Planning Application to Amend North Runway Layout

CLG 07/02/19

Where are the amendments on the Runway & taxiways?

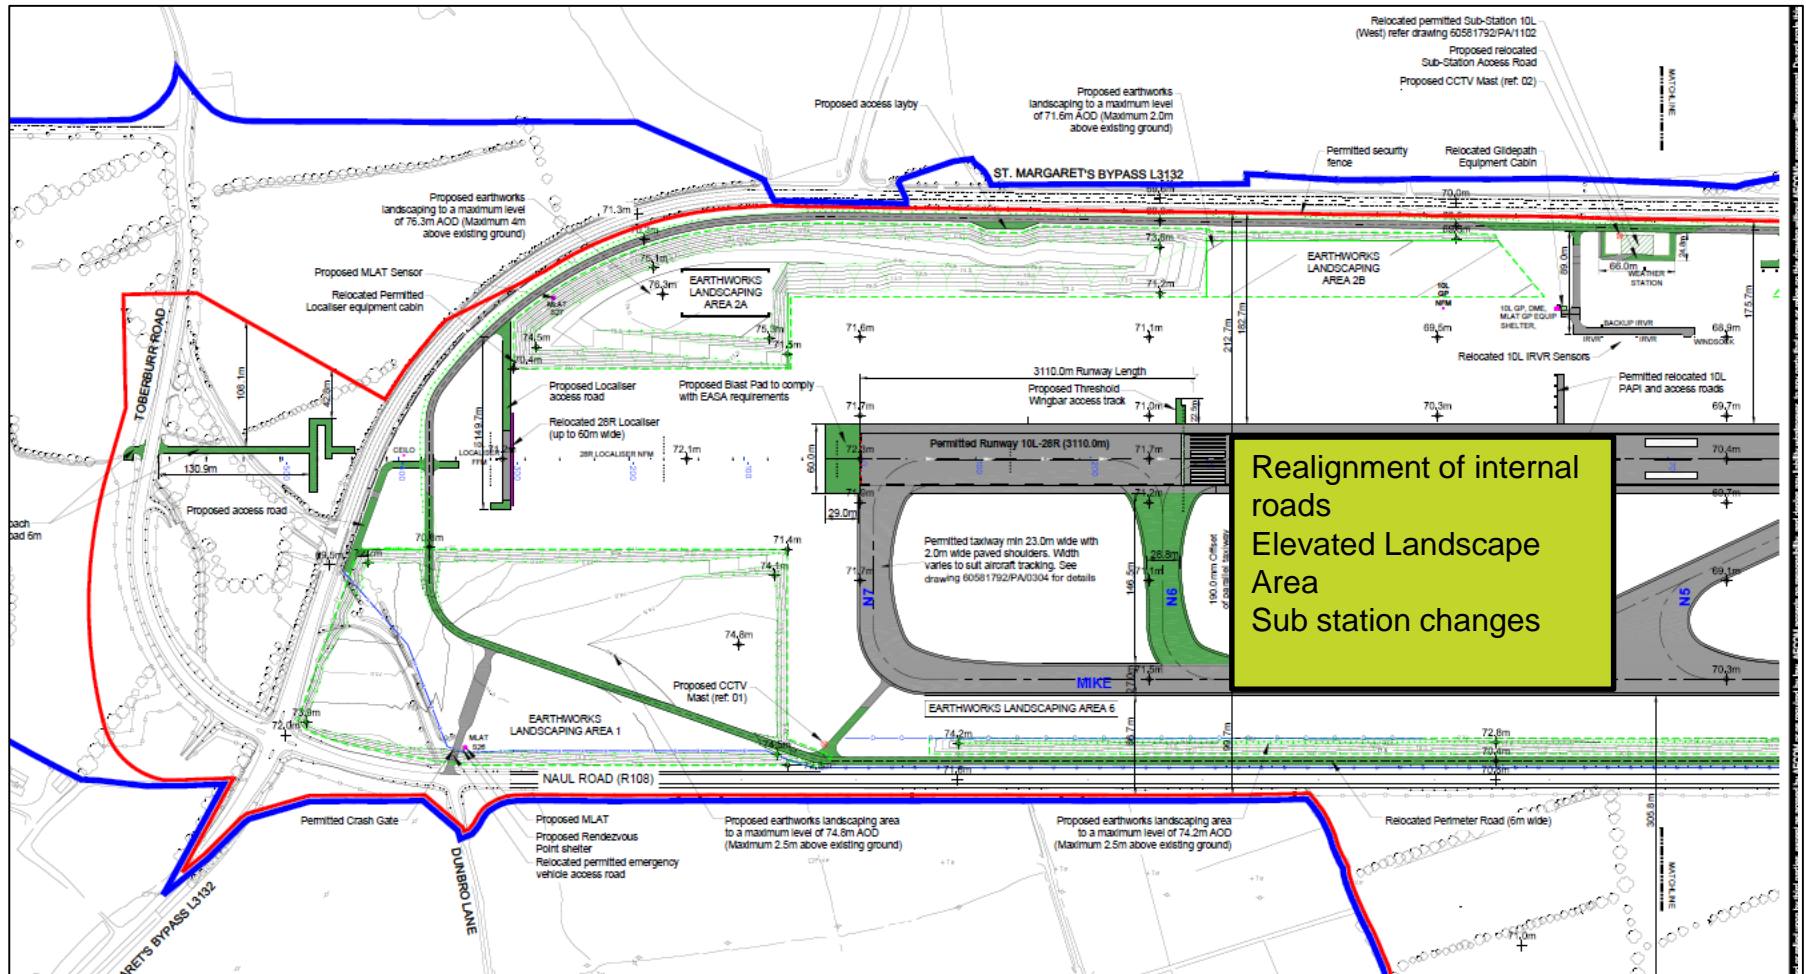
- Changing the outer 7.5m of runway shoulders to reinforced grass
- Reducing the width of the taxiways
- Reducing the number of Rapid Exit Taxiways
- Blast pads (to prevent blast erosion) at runway ends
- Minor amendments to sub-stations and their access roads
- Maintenance access roads for vehicles.
- Re-aligning and re-locating fire access roads
- Elevated landscaped areas
- Removal of security entrance Gate 1A
- CCTV masts and airside blast fencing.
